ONE SYDNEY HARBOUR

BARANGAROO

R4A SUPPLEMENTARY DESIGN STATEMENT FOR S4.55 MODIFICATION APPLICATION
June 2021

R4A Site Plan - Approved

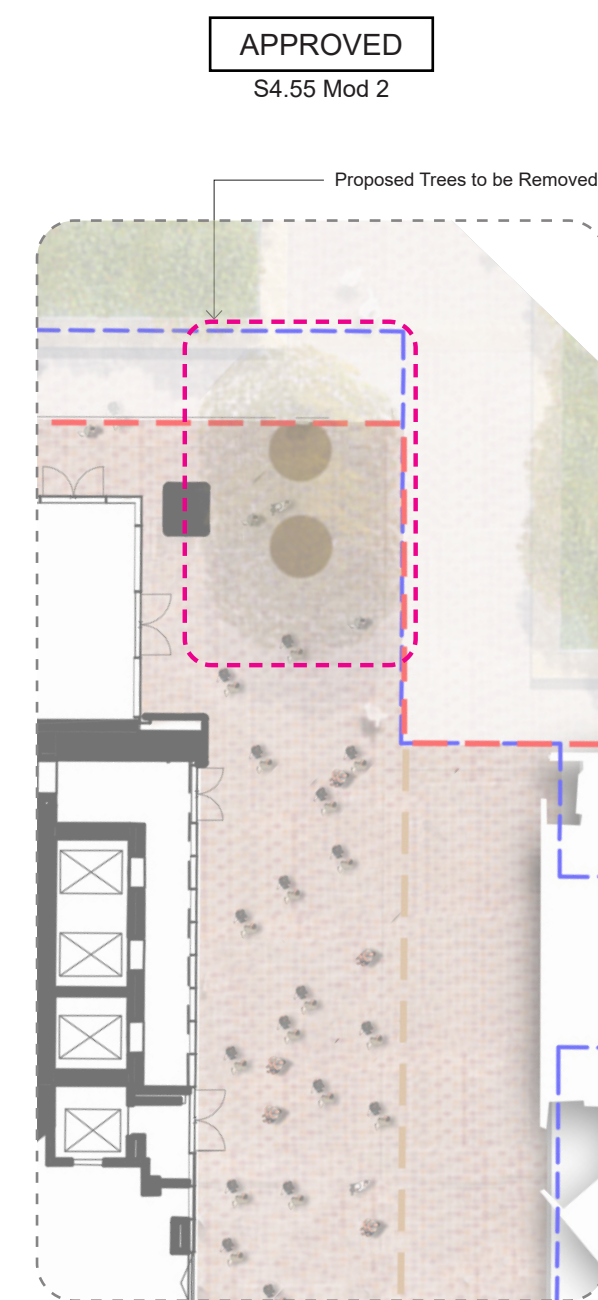
Through this planning amendment it is proposed to transfer the approval of the Strada ground plane from the Building R4A Development Consent (SSD 6964) to the Building R4B Development Consent (SSD 6965) so that the entirety of the Strada (including the ground plane and the roof structure above) sits within the same development consent being Building R4B.

As a result, the development application boundary extent has been revised, and an administrative transfer of conditions which relate to the Strada is also proposed as part of this modification.

Proposed GF Landscape Plan

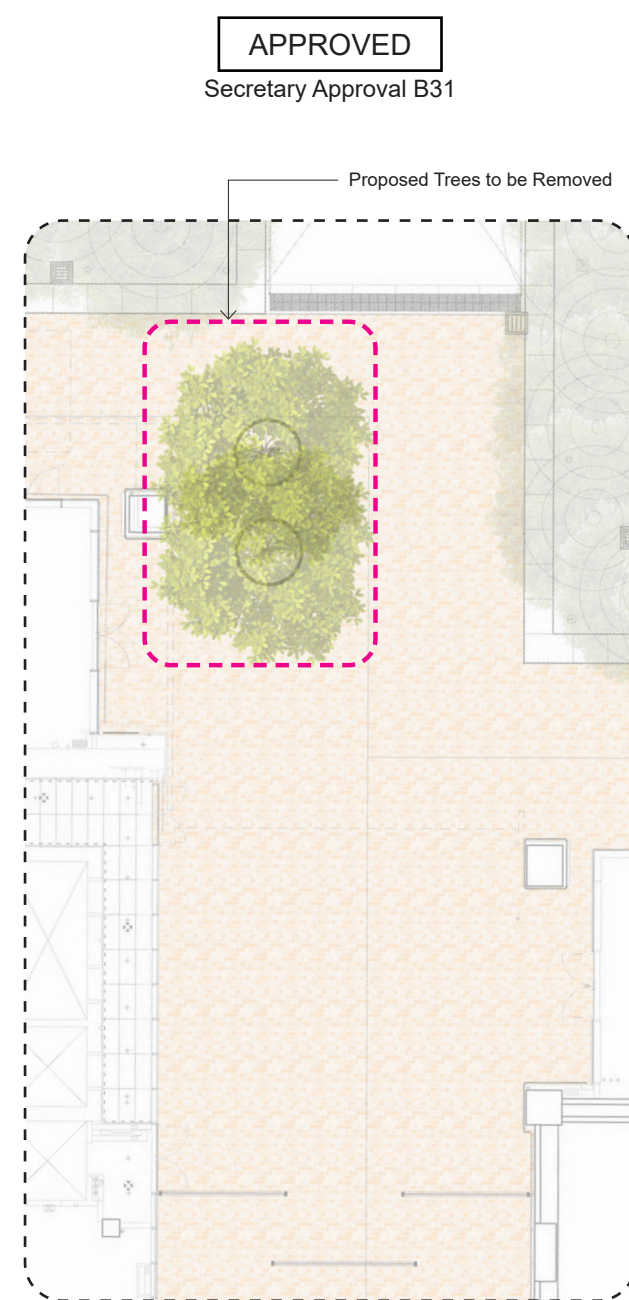
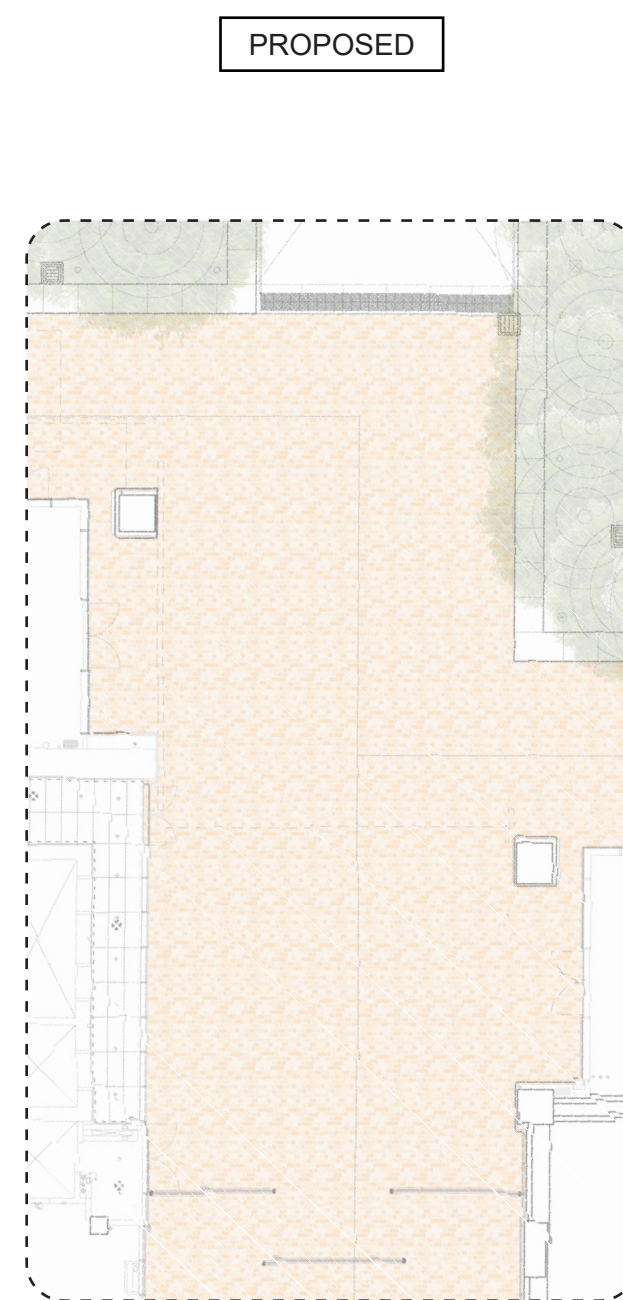
Two trees adjacent to the parkside tenancy and at the entry to Hickson Park are included in the approved landscape plan shown on the left.

This proposal seeks to remove the two trees for the following reasons.

The two trees were located in the original development consent for Building R4A (2017), prior to the design and approval of the adjoining Barangaroo Public Domain (SSD 7944), including Hickson Park in 2018. Hickson Park includes 65 trees, including 53 in a 'tree belt' directly adjacent to the Towers and 12 in the broader Park area. The public domain areas around the Towers entrances on the Hickson Park frontage are generally open paved areas, providing clear pedestrian access to and from these buildings and also and 'frame' the tree belt. These two trees therefore are not consistent with the ground plane character around the Towers to Hickson Park, and their removal would provide a more consistent public domain outcome.

Further, the impact of the two trees on the wind mitigation is negligible. The tree belt in Hickson Park provides significant tree planting with soil zones and clear space to support developed trees in height and canopy to assist with the wind mitigation for this area. The two trees proposed to be removed will have a restricted canopy in this location.

The removal of these trees will ensure also support clearer pedestrian access at the entry to Hickson Park and improve the visual connectivity from Hickson Park through to the Strada. In addition, the visual and ecological loss of those two trees is managed with the significant degree of tree planting approved through the Barangaroo Public Domain SSD 7944, especially the trees in adjoining Hickson Park.

"Windtech is satisfied that the removal of these 2 tress [sic] will have a negligible impact upon the wind environment"

Proposed Entry vestibule - Plan

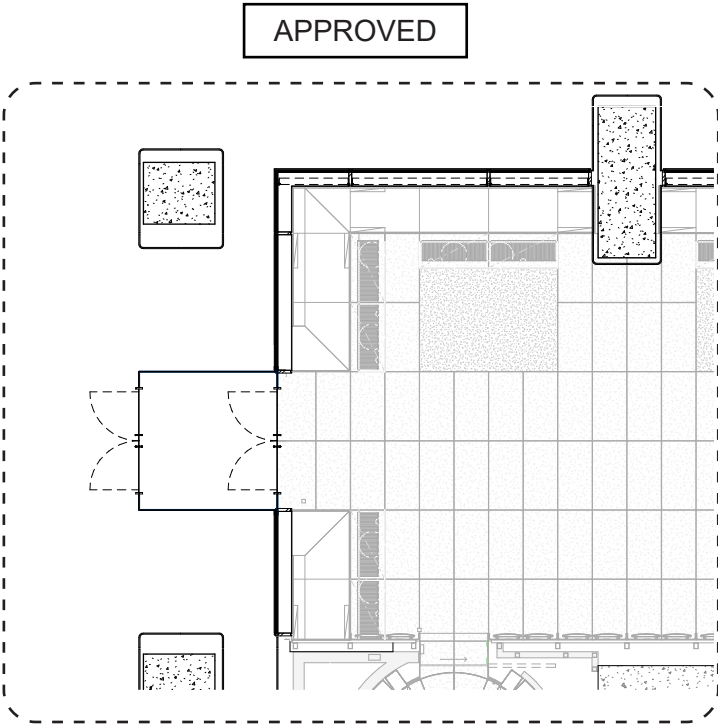
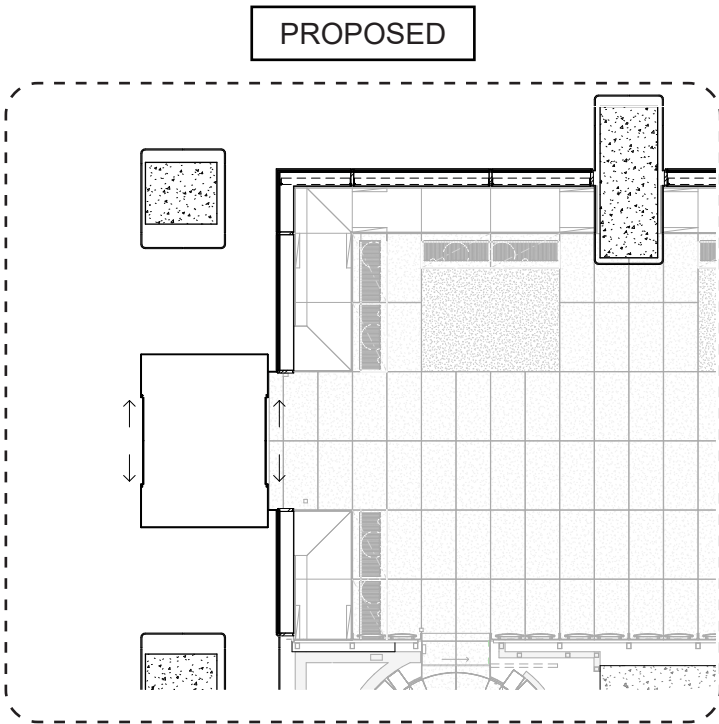
Automated sliding doors have been integrated in lieu of swing doors, improving operability as well as creating a seamless transition from outside to the residential lobby interior.

Through detailed review with the project consultant team it has been determined that a sliding door system would provide a more robust, reliable and fit-for purpose solution.

This amendment has resulted in a minor adjustment to the dimensions of the lobby vestibule. This amendment has been integrated into the modulation, proportion and geometry of the facade to provide a design response that meets the design standards of the precinct architecture.

2.4 Revised Signage Zone Location

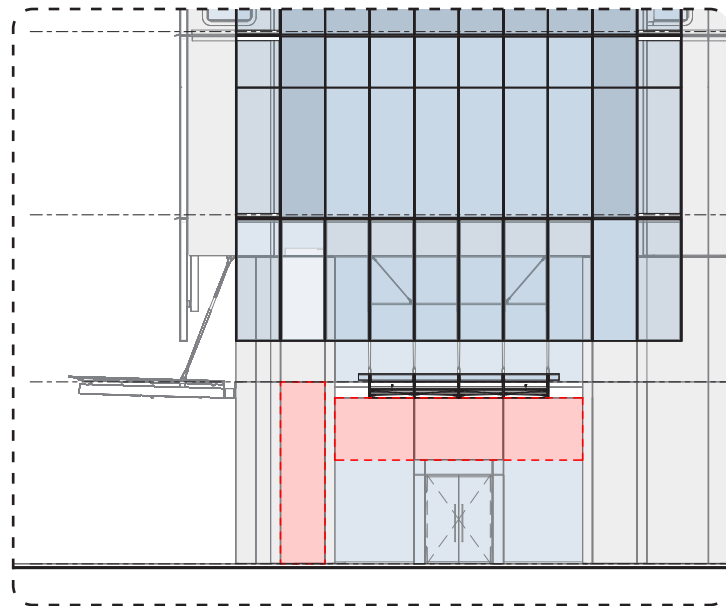
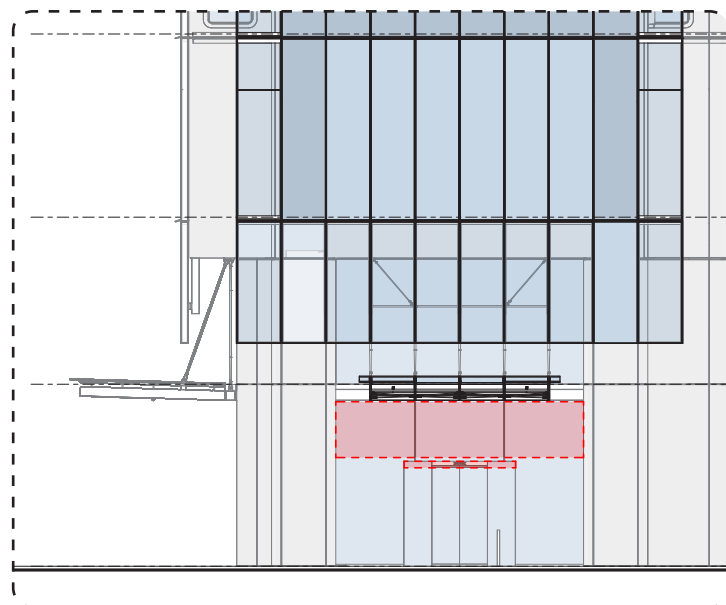
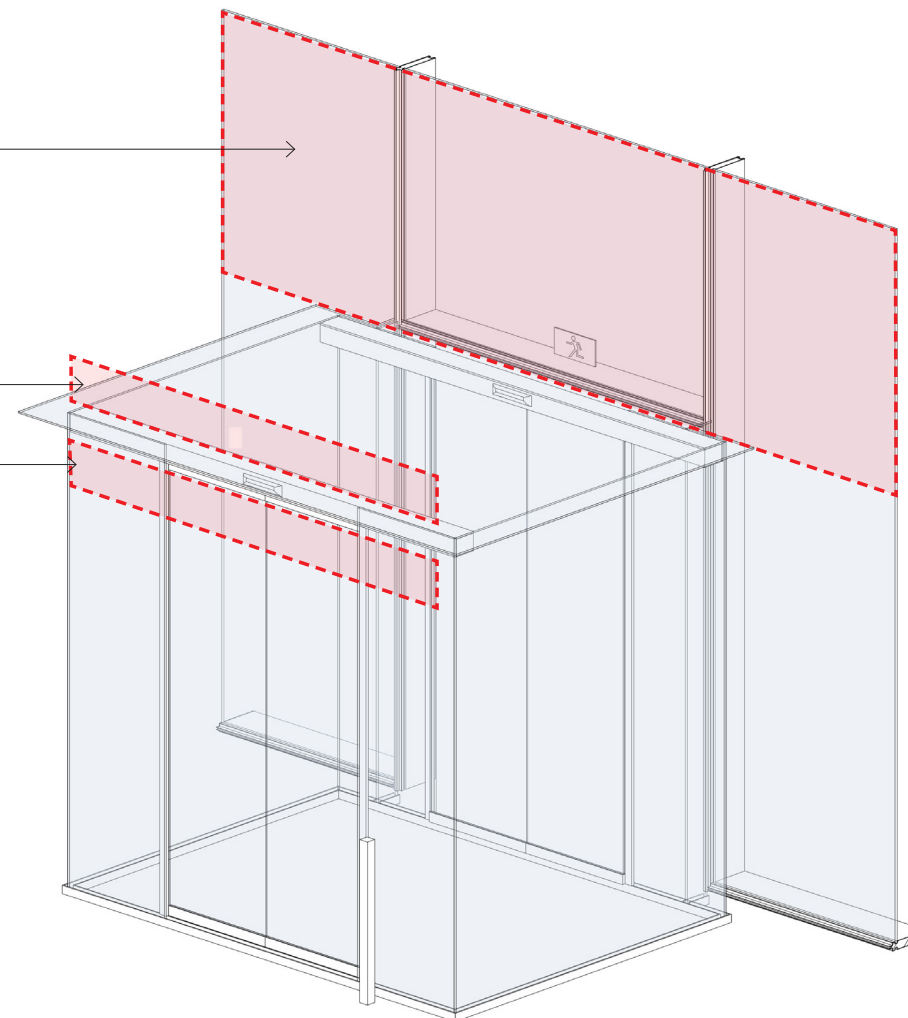
Further detailed development on building signage has been undertaken and it is proposed to revise the location of the entry vestibule signage zone as shown on the left.

The already approved zone above the entry vestibule box has been extended to include a potential signage on the glass above the door.

Depending on the final design the signage may be located either on the glass or above the vestibule volume.

In addition, the secondary approved signage zone located on the adjacent column is no longer deemed to be required and has been removed.

NOTE: The intent is to have only one signage, that depending on the final design will be either on zone 1,2 or 3.

Proposed L58 Plan - Upper Floor Plate

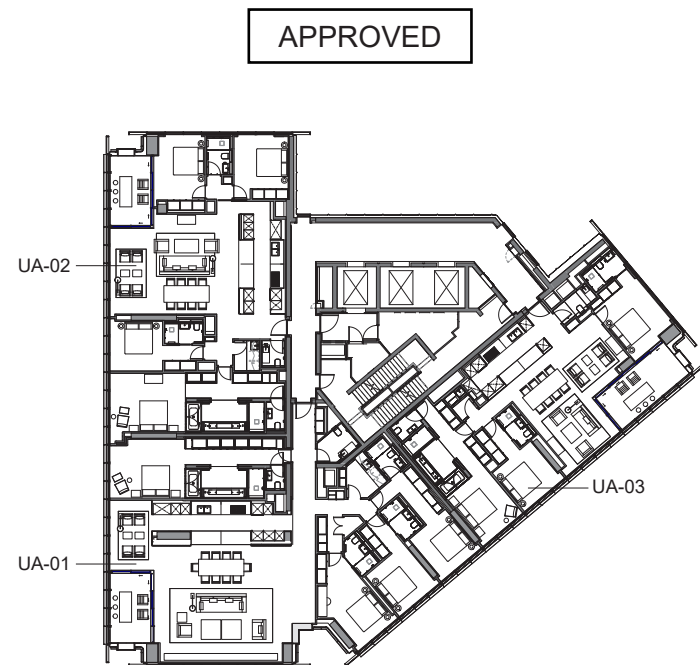
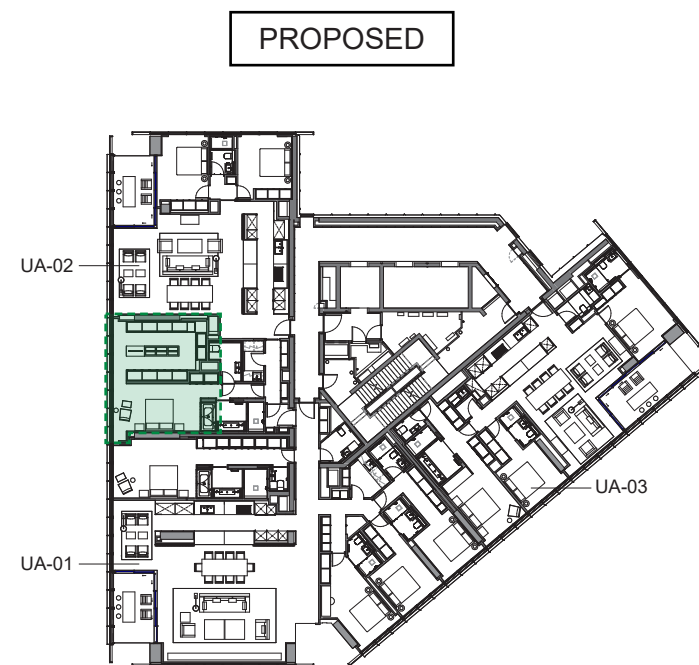
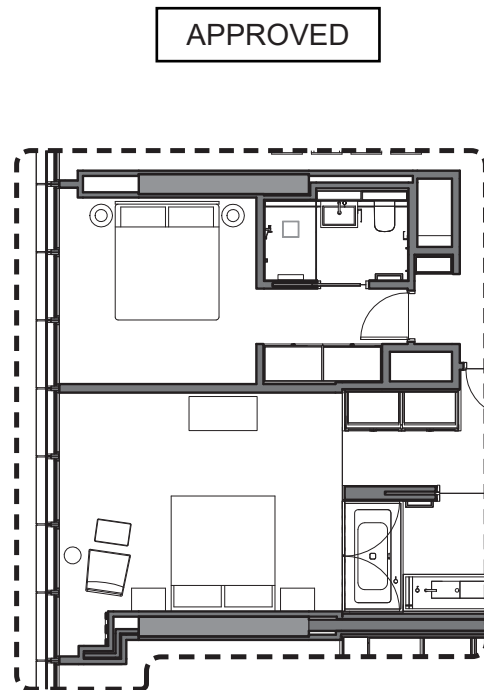
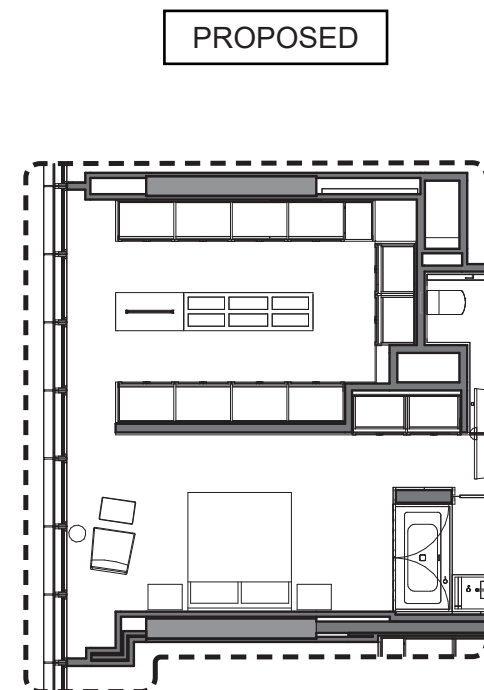
A minor internal layout modification is proposed for the Level 58 UA-02 apartment through the creation of a walk-in-robe to the master bedroom in lieu of a secondary bedroom, reducing the overall bedroom count from 4 to 3. This proposed change has been part of a design refinement process to cater to specific purchaser needs whilst ensuring a high quality overall apartment design is maintained
